Title: Valor on Washington

Re: Urban Design Commission Application - Final
Valor on Washington: 1322 East Washington Avenue

Enclosed are updated plans for the project known as Valor on Washington. In response to feedback at the June 12, 2019 UDC meeting, we have made the following adjustments:

Sheet No.
A203

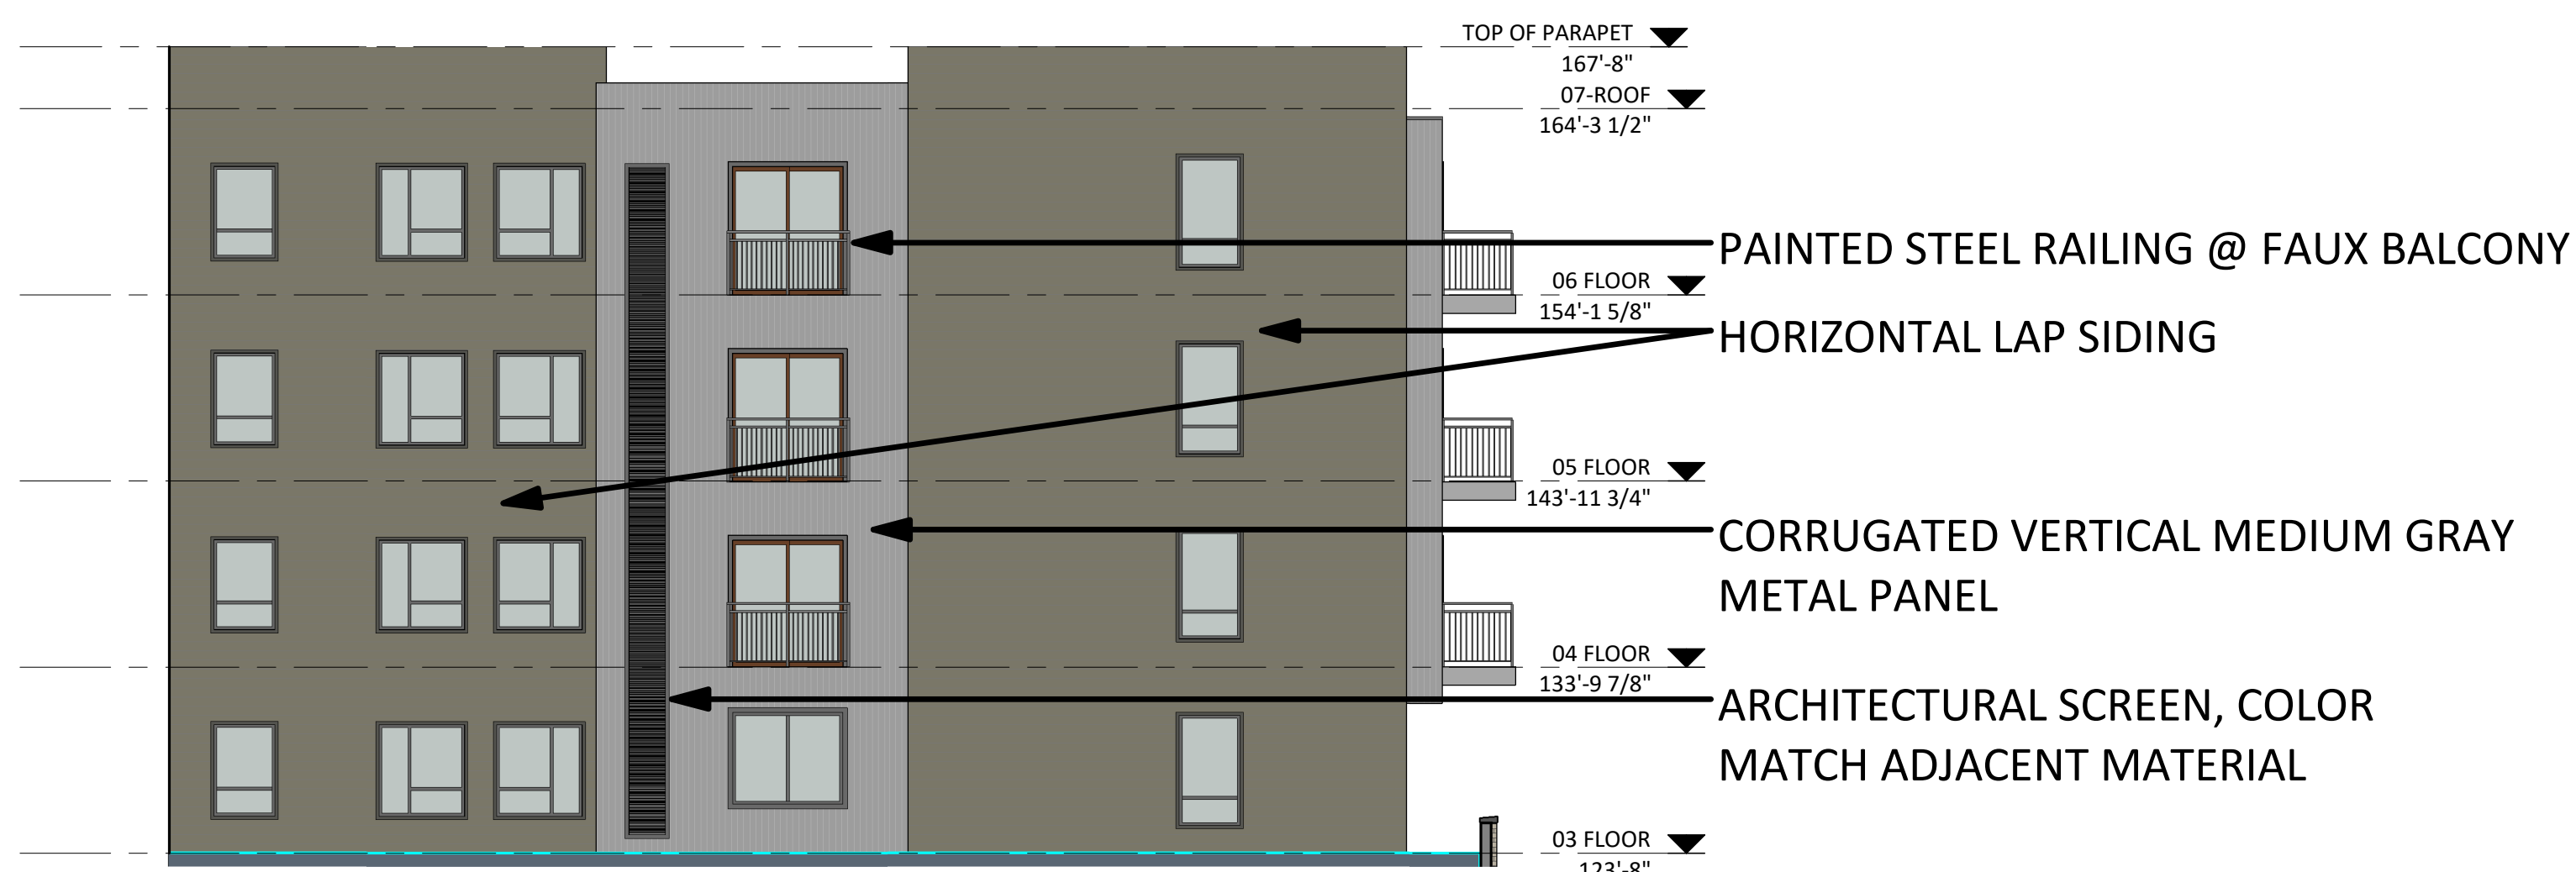
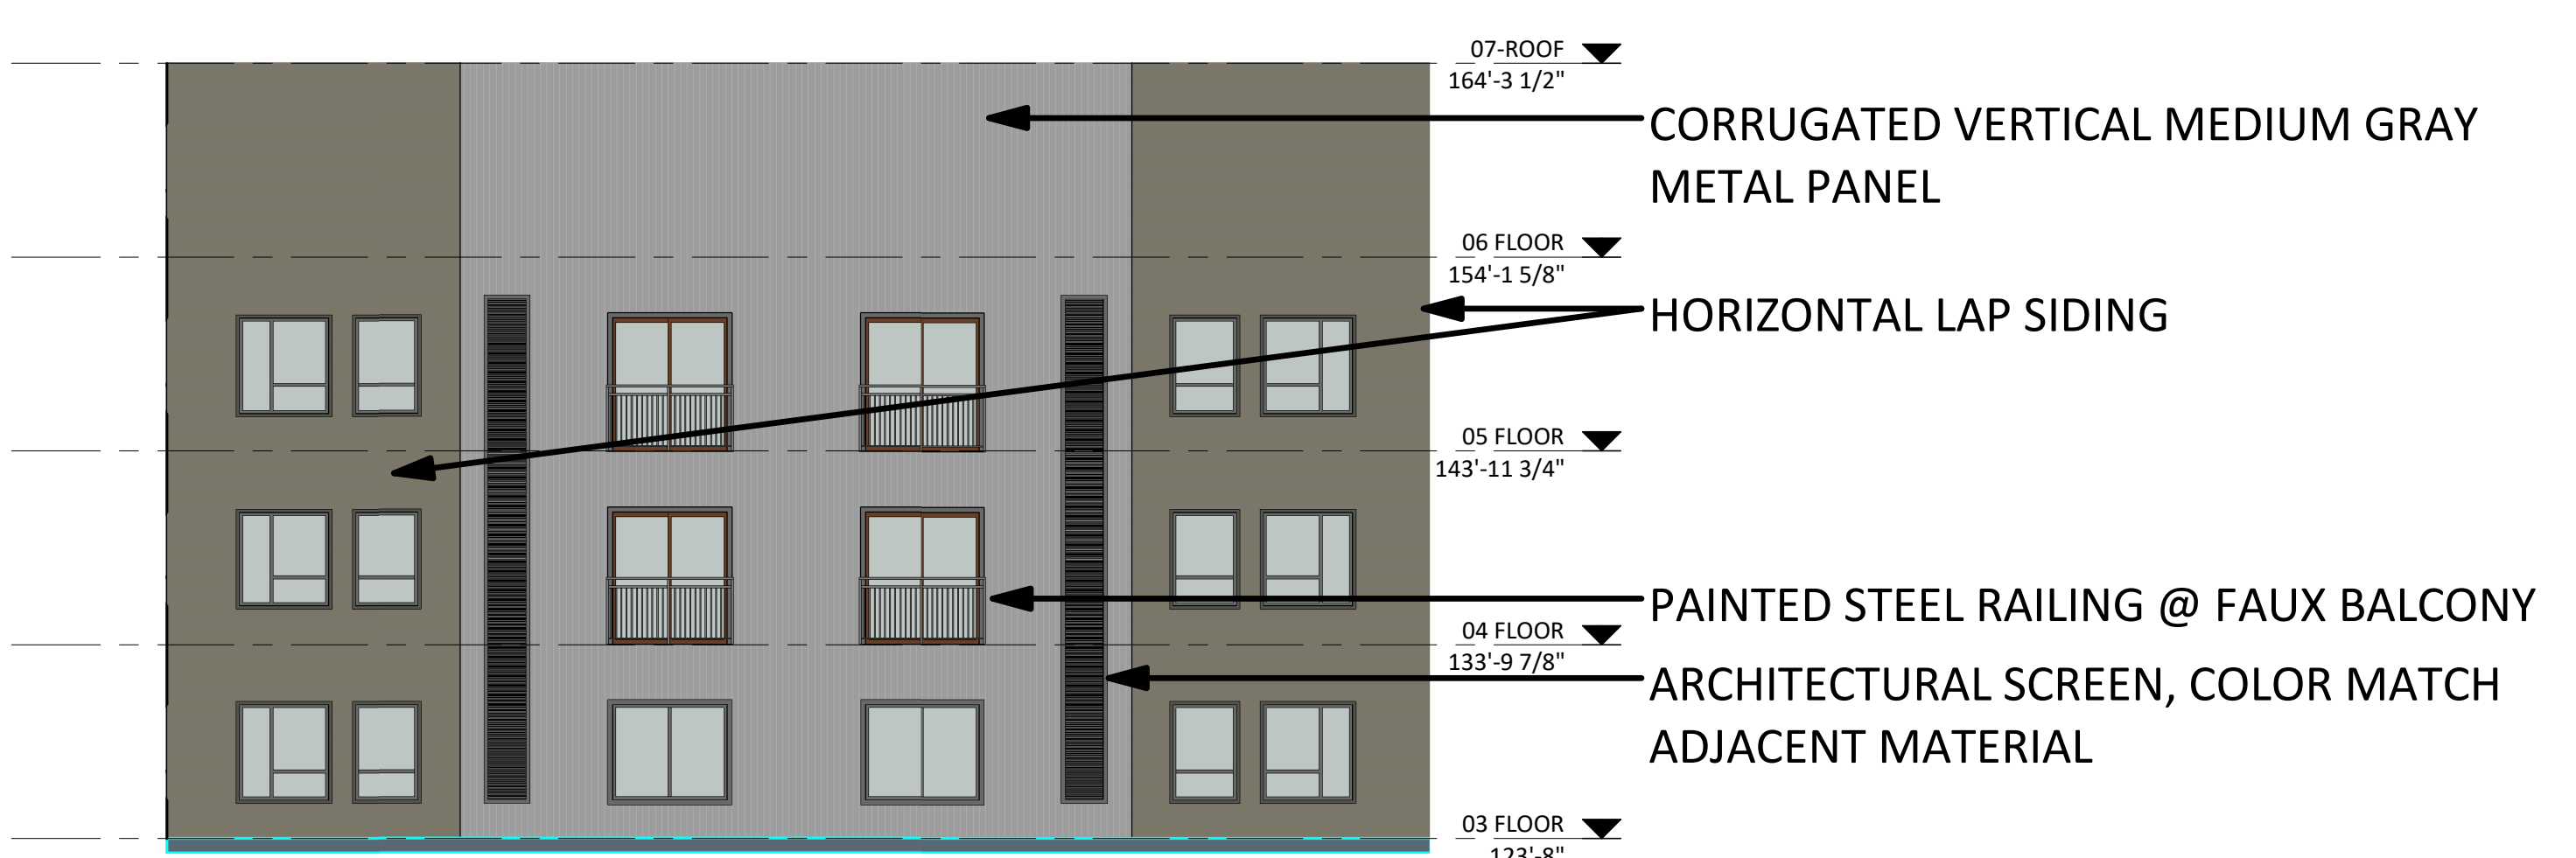
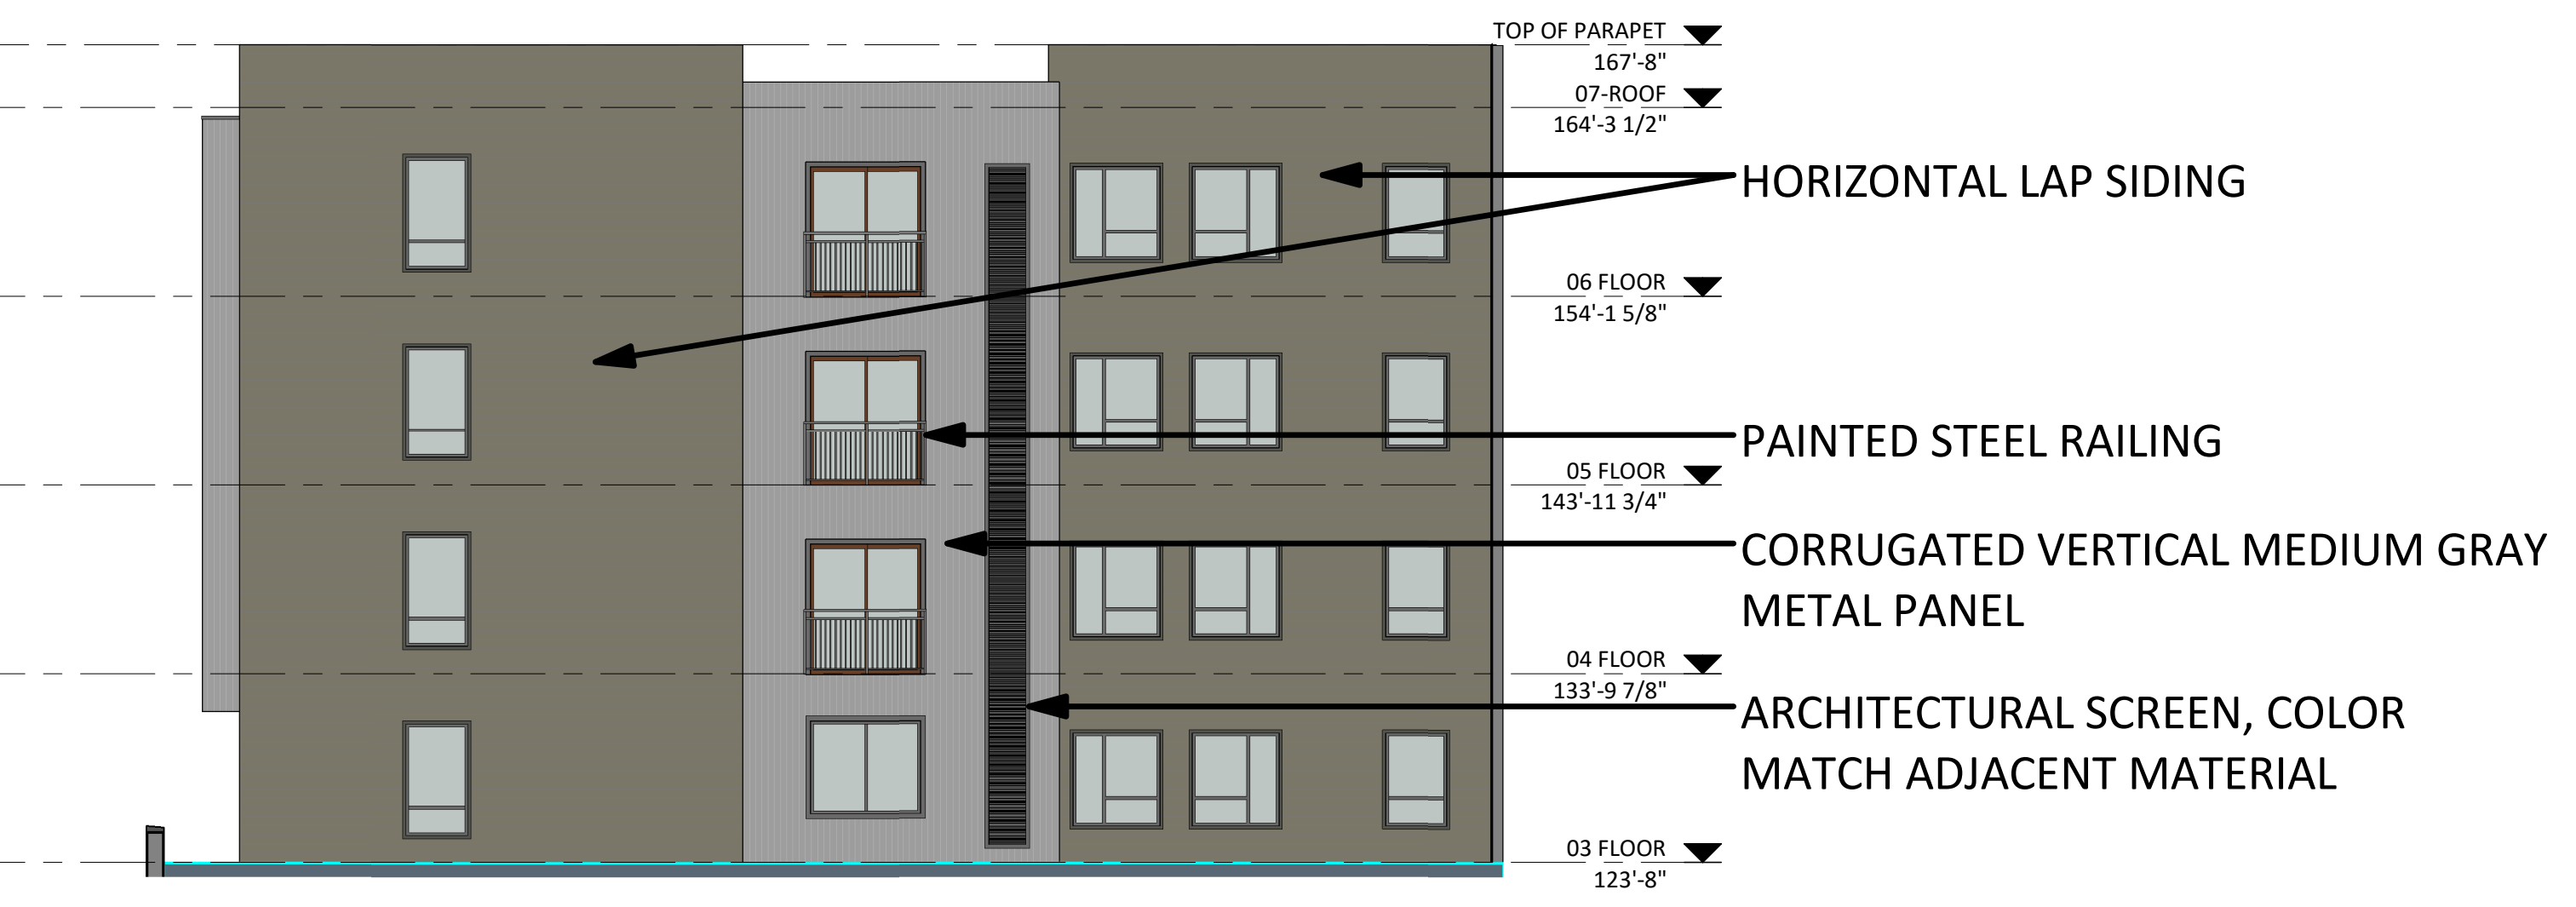
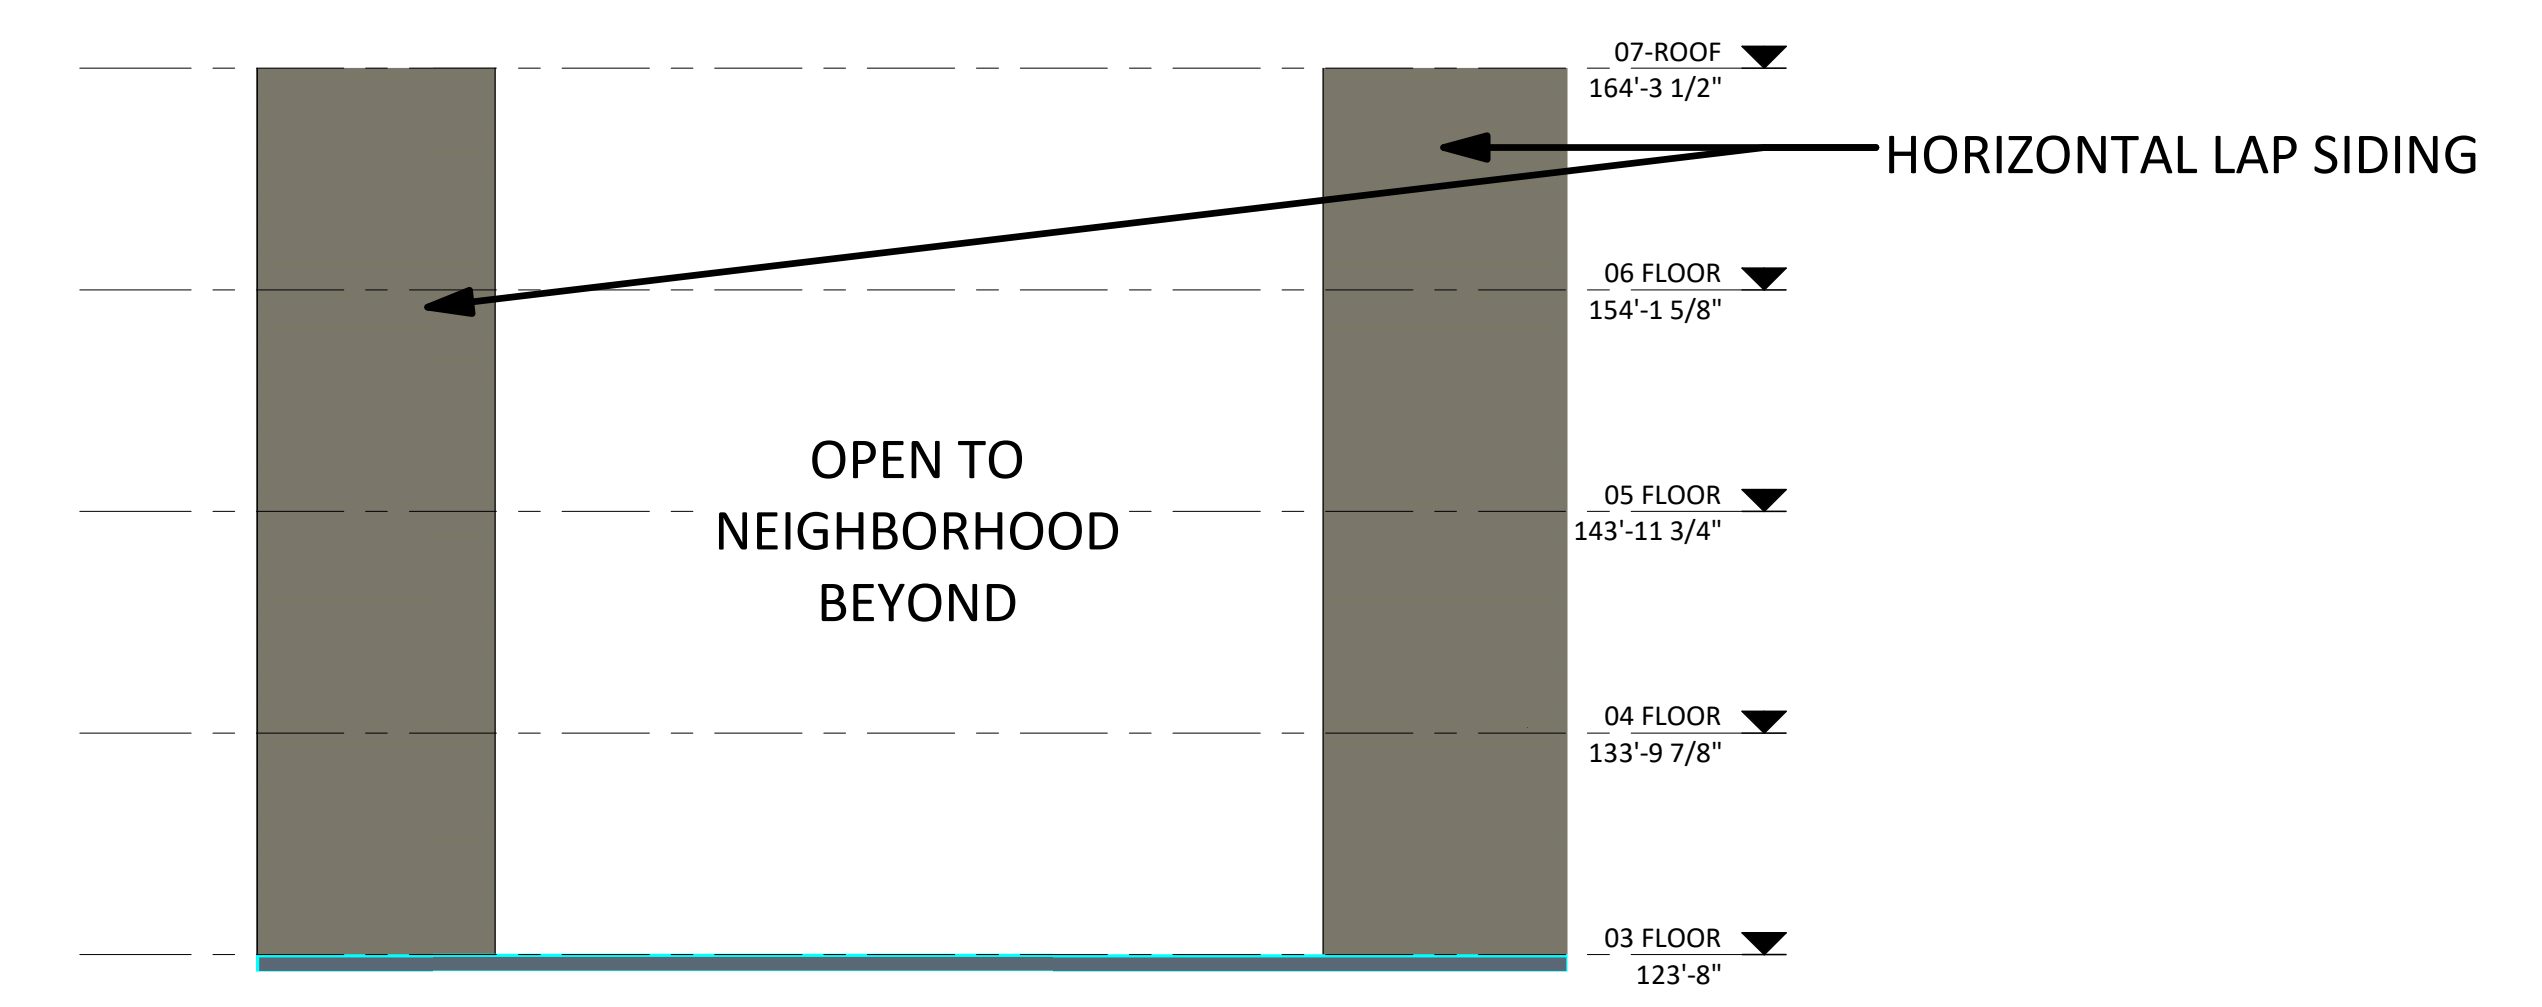
- *Metal panel gauge and installation method:* This detail shall be provided at June 26th meeting.
- *Elevation drawing views of all interior facades:* Elevation views for the north-facing lower roof building elevations are enclosed. Please refer to sheet A203.

- *Consider simplifying the material palette:* The elevations enclosed represent the following simplifications to the building elevations and materials. 1) At the request of the commission, brick has been removed from the north-facing lower roof building elevations. 2) The townhome facades material configurations have been modified/simplified. 3) the north-west building corner has been modified/simplified. Specifically, the lap siding inset has been changed to metal panel.
